RE: Mayflower Inn & Spa – Event Tent
Acoustic Peer Review

SH Acoustics (SHA) has conducted a peer review of the documentation associated with the special permit application for the Event Tent at the Mayflower Inn & Spa in Washington, CT, related to sound transmission to the neighboring properties. The relevant documentation includes the Brooks Acoustics Corporation (BAC) report, Subject: Hospitality Tent Acoustical Design, and the Powerstation Events white paper, “Mitigation plan, elements, and procedures for sound control and localization,” both dated 12 November 2021.

Figure 1 Parcel map of the area surrounding the Mayflower Inn & Spa

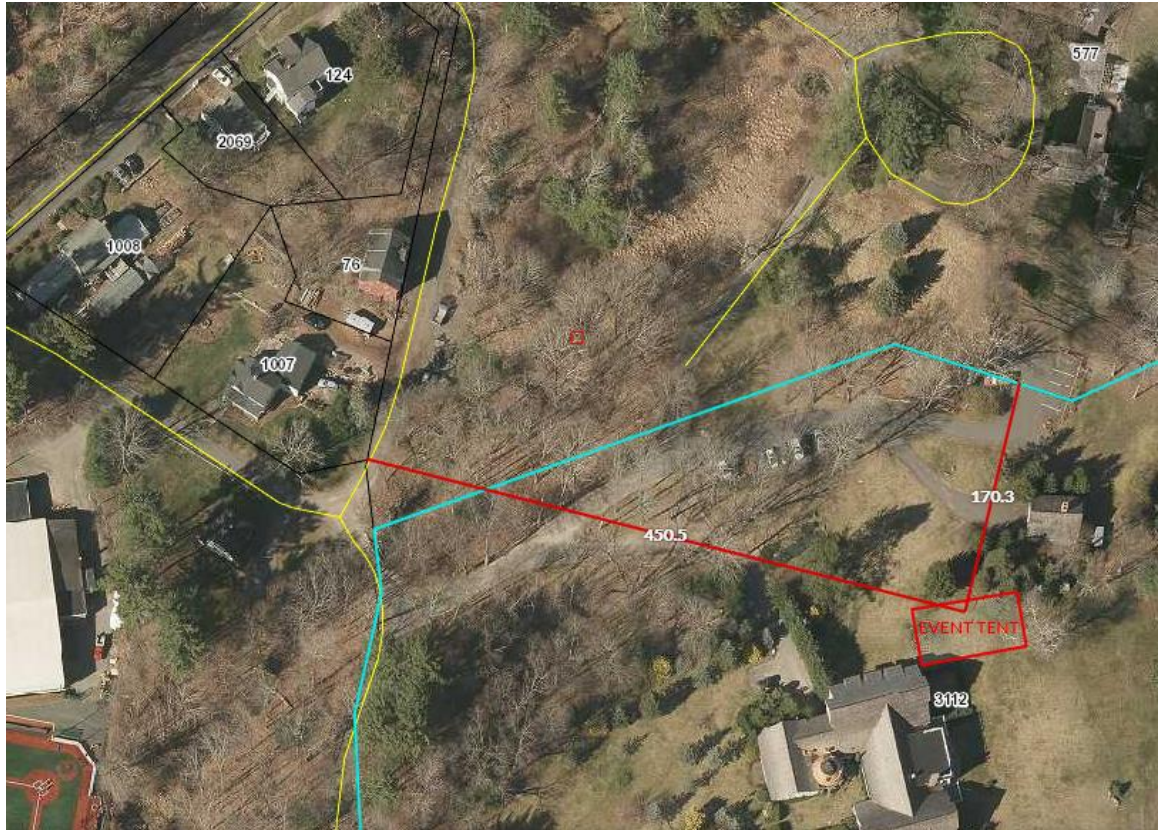
10. BAC then indicates that a monitoring system will be implemented to ensure that the sound level limits set by the State of Connecticut "at the nearest neighbor (~500 feet distance)." This presents a few issues:
 - a. The Regulations of Connecticut State Agencies (RCSA Section 22a – 69) states that "measurements taken to determine compliance...shall be taken at about one foot beyond the boundary of the Emitter Noise Zone within the receptor's Noise Zone." Based the Town of Washington parcel map below (Figure 1), the nearest relevant boundary (property line of a residential property) appears to be located approximately 170 feet north of the Event Tent.

- b. The next closest residential property line, that of the neighbor considered in BAC's study, is approximately 450 feet northwest of the Event Tent.
